18th OCE Plenary Meeting San Francisco October 16/17, 2007

Off-Cycle Emissions (OCE) GTR
OICA Proposal for Amendment

WNTE Components

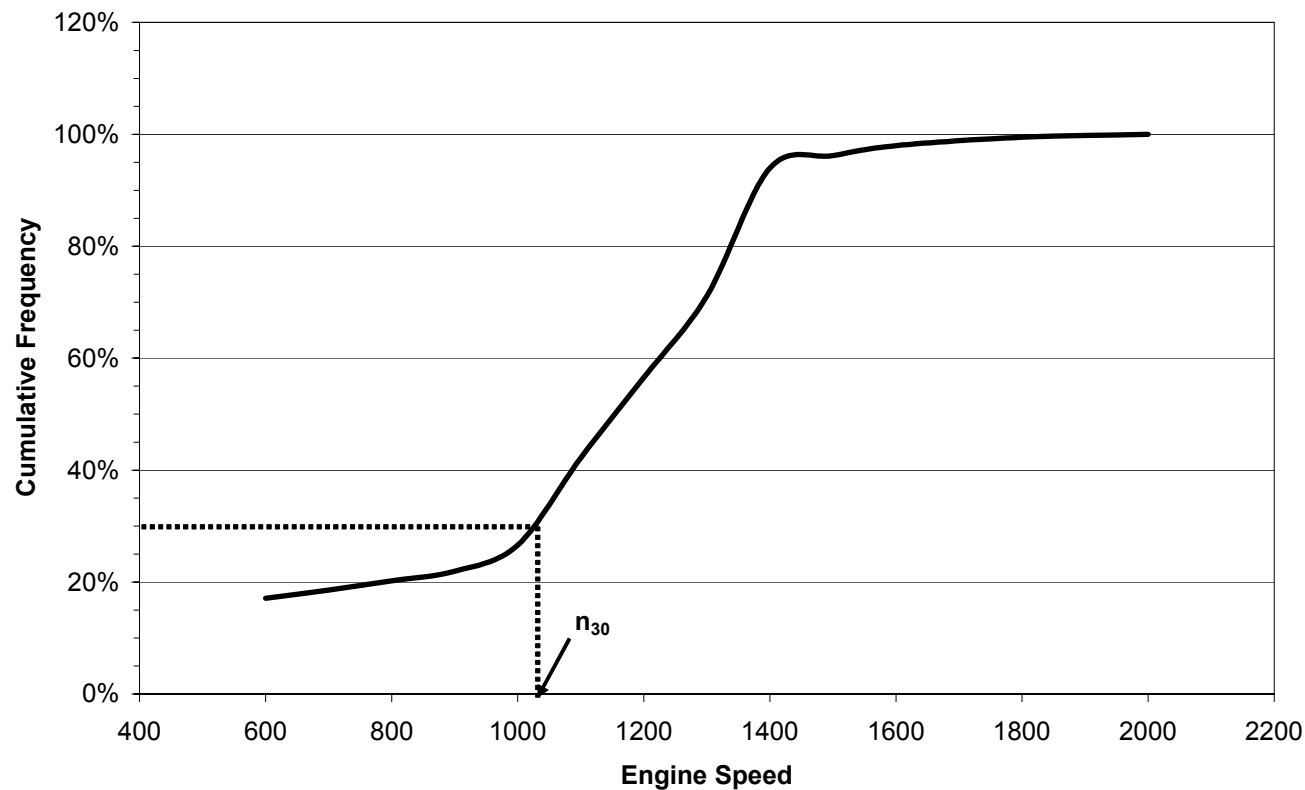
- ❖ Since the OICA proposal uses an additive component (or constituent), the expression "WNTE factor" can not be used
- ❖ Rounding of the WNTE component to the same number of places as in the applicable standard
- ❖ The proposed WNTE components are shown below:

for NO _x :	$WNTE \text{ Component} = - 0.0248 * EL^2 + 0.2946 * EL + 0.0963$
for HC:	$WNTE \text{ Component} = 0.15 * EL^2 + 0.01 * EL + 0.09$
for CO:	$WNTE \text{ Component} = 0.025 * EL^2 + 0.1 * EL + 0.2$
for PM:	$WNTE \text{ Component} = 1.25 * EL^2 + 0.0875 * EL + 0.005$

WNTTE Control Area

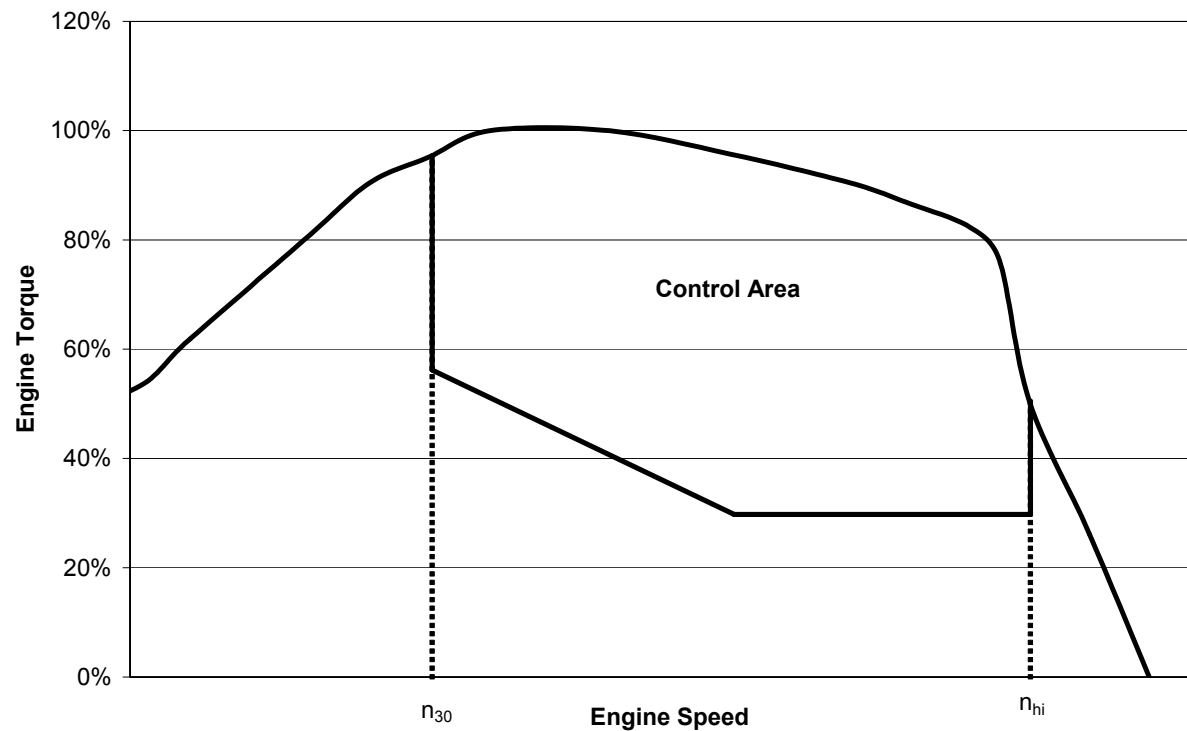
- ❖ Lower engine speed range: n_{30}
- ❖ Upper speed range: n_{hi} , but no further carve-outs
- ❖ Torque/power limit of 30%, as in the USA
